Subject: SEP Topic III-5.A, Effects of Pipe Break on Structures,  
Systems and Components Inside Containment  
R. E. Ginna Nuclear Power Plant  
Docket No. 50-244

SEP TOPIC III-5.A  
HIGH ENERGY LINE BREAKS INSIDE CONTAINMENT

R. E. GINNA NUCLEAR POWER PLANT  
DOCKET NO. 50-244

FIGURE - 1

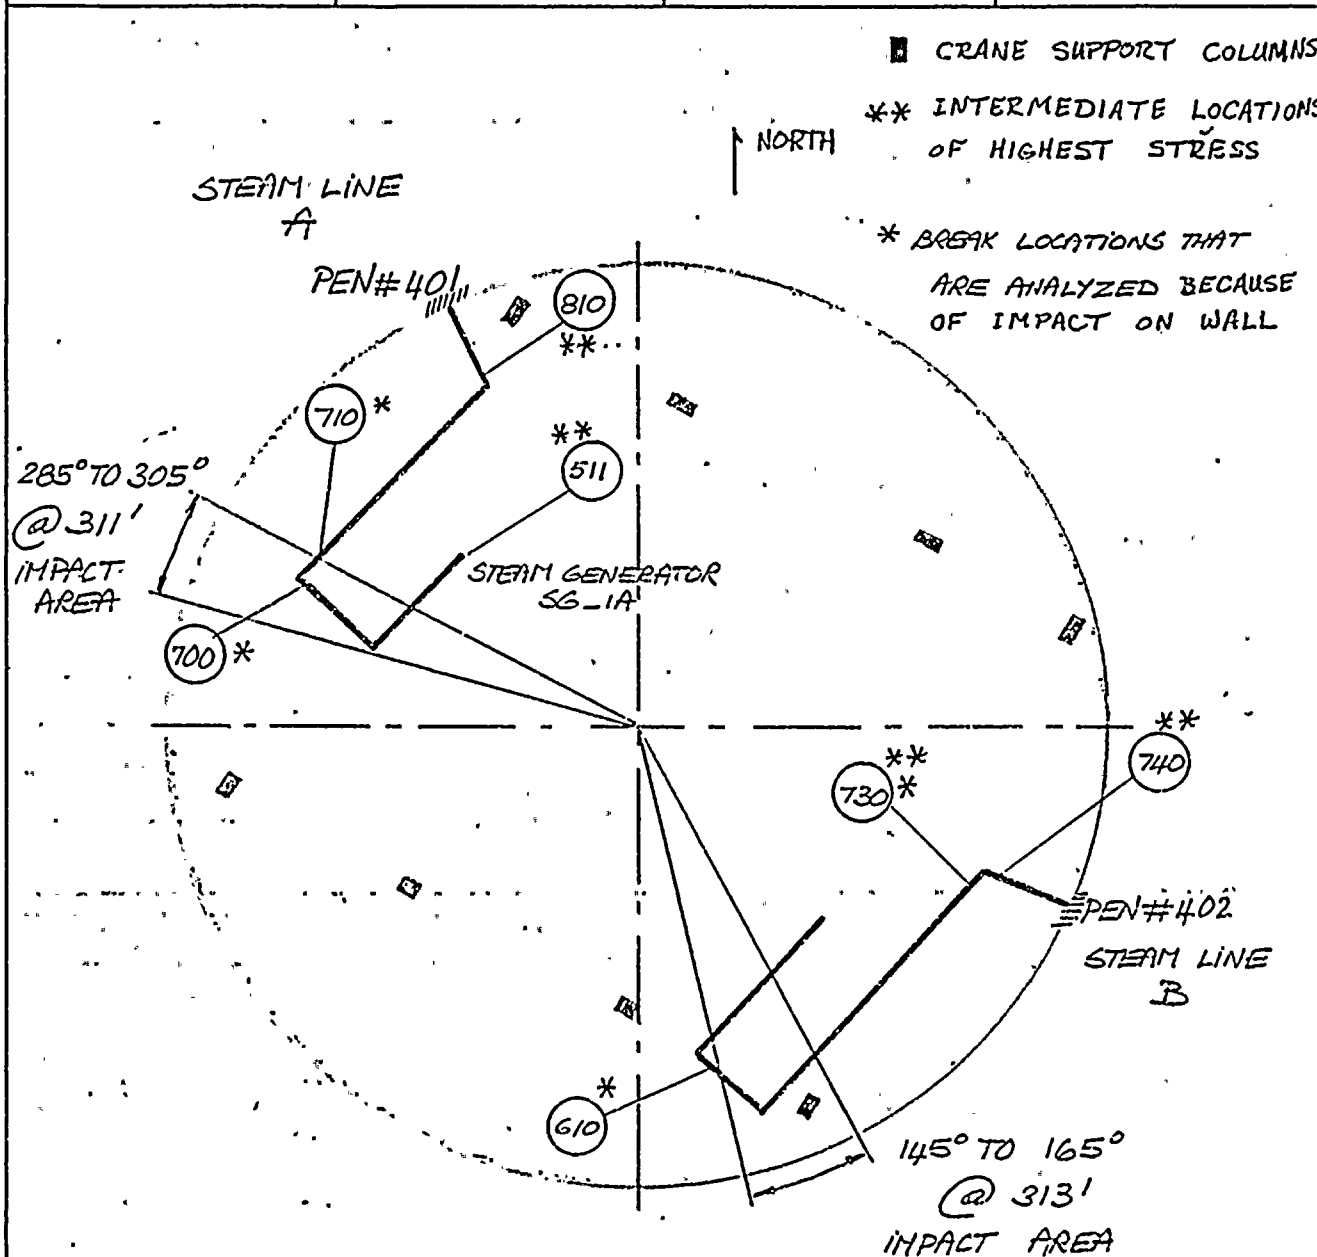
2. A break in either a main steam or main feedwater line could impact the containment wall. The licensee must demonstrate that the pipe whip will not result in penetration of the containment wall. If some loss of containment function occurs an assessment must be provided of the consequences.

Because an effects-oriented evaluation of the main steam and feedwater lines could not rule out the potential for a ruptured line striking the containment wall, a mechanistic evaluation of the main steam line was performed. The analysis methods used made evaluation of the main steam line a conservative envelope for both main steam and feedwater line rupture effects upon the containment wall. The thrust force applied by the escaping fluid to the pipe was calculated by multiplying the initial pressure by the pipe cross-sectional area. The steam line force calculation thus envelopes the feedwater force calculation. The evaluation of pipe whip effect on containment wall integrity was performed for both main steam lines A and B. The piping stress analysis results from the RGE seismic upgrade program were used in the evaluation. The piping break locations were postulated at the following locations:

Table 1 provides the location of the maximum stress combinations  $S_{O1} + S_E$  for each main steam line; these locations are shown in Figure 1.

Since none of the combinations  $S_{ol} + S_E$  exceeds the stress limit, circumferential breaks are assumed at the two intermediate points of maximum stress.

These variables have been evaluated for the break cases considered in Figure 1. In this evaluation, the effect of the existing pipe supports and the crane structure were neglected to maximize the impact upon the wall. This is conservative since these restraints tend to decelerate the pipe motion and, therefore, decrease the striking velocity  $v_o$ .

The results of the analysis are provided in Table 2 and the impact zones of the containment wall are shown in Figure 1.

It should be noted that the two intermediate locations of highest stress do not result in an impact on the containment wall and therefore no further analyses are required. Nonetheless, to provide additional confidence that postulated breaks will not yield a ruptured containment wall, the highest stressed location in each steam line which results in an impact upon the wall has been evaluated. The locations considered are #700 on MSL A and #610 on MSL B (see Figure 1).

For break location #700: MSL "A"  $X = 13.96"$   
For break location #610: MSL "B"  $X = 3.48"$

The conclusion of these analyses is that, even neglecting the three-eighths inch steel liner plate, structural integrity of the containment shell is assured.

Figure 2

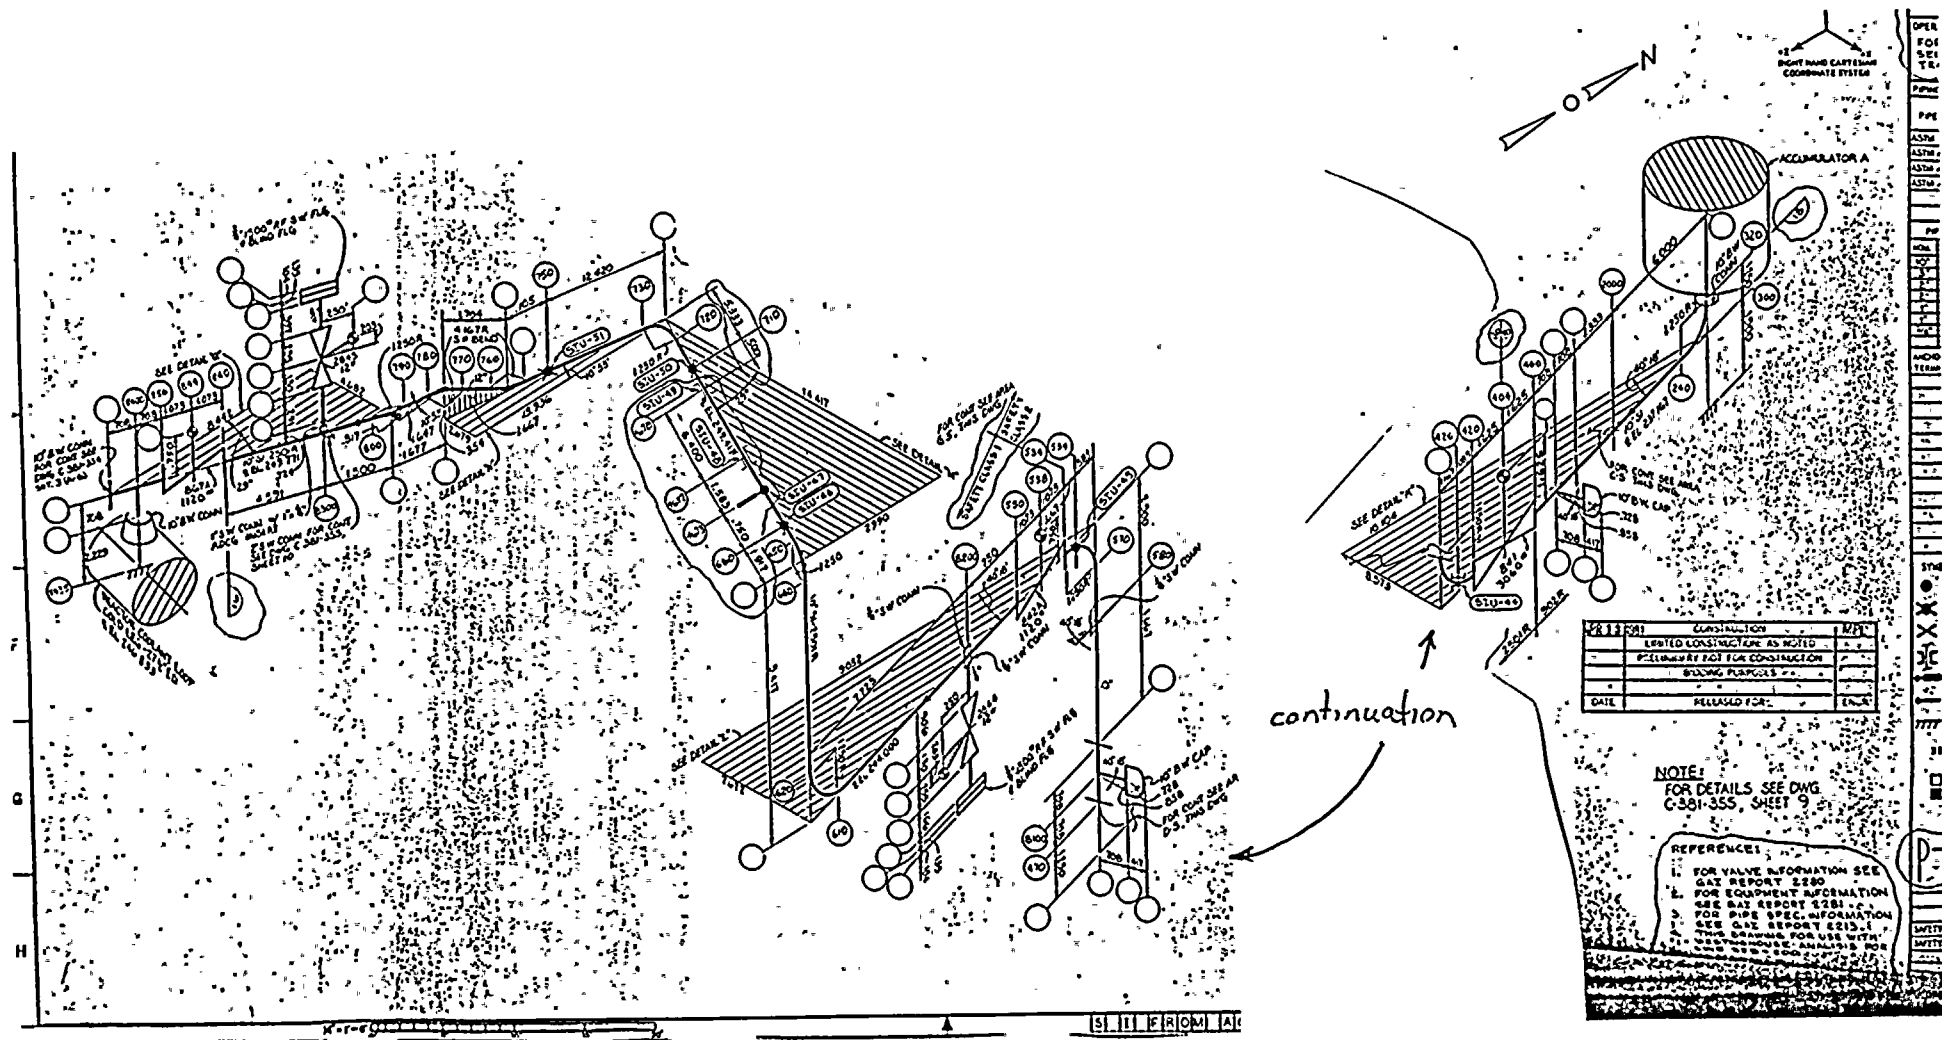
4. A break in the accumulator line between the tank skirt and the loop compartment walls could interact with the LPSI lines (resulting in a LOCA) and with the RHR outlet line. A break could also impact containment spray or safety injection lines. Breaks in this line could also interact with cables for instrumentation circuits, the LPSI valve controls and fan coolers. The licensee must demonstrate that the consequences of this scenario are acceptable, provide restraints and protection or demonstrate that breaks need not be postulated in this area based on a mechanistic evaluation.

The second intermediate location is at node 420 near valve MOV 841 and is shown in Figure 2. The stress at this location is less than 4000 psi. The allowable stress is greater than 27,000 psi. The stress at node 420 is so low that a break at this location should not be postulated.

If a break is postulated at node 420, piping downstream of the node will not whip because the line is filled with cold water with no sustained high energy source available. Check valve 867A prevents blowdown of the RCS. The line between the elbow at node 420 and the tank skirt is a straight run of piping near the floor and separated from the LPSI line by at least 15 feet, a distance greater than the length of pipe between the tank skirt and node 420. Portions of the RHR line are closer to the accumulator line but are also out of reach of the pipe segment between the tank skirt and node 420. Valve 700, located in the A loop compartment, provides isolation from the primary system. If a rupture is postulated at node 420, the pipe may deflect downward or even strike the floor but the pipe deflection will not be toward the RHR line or the LPSI line (see drawing E-303-603 in reference 1).

Therefore, rupture of the 10 inch accumulator line should not be postulated because of the applicability of "leak before break" established by TAP A-2 work and because stresses in the line are very low. Further, even if rupture of the line at the two highest stressed intermediate locations is postulated, the break will not adversely affect required equipment.
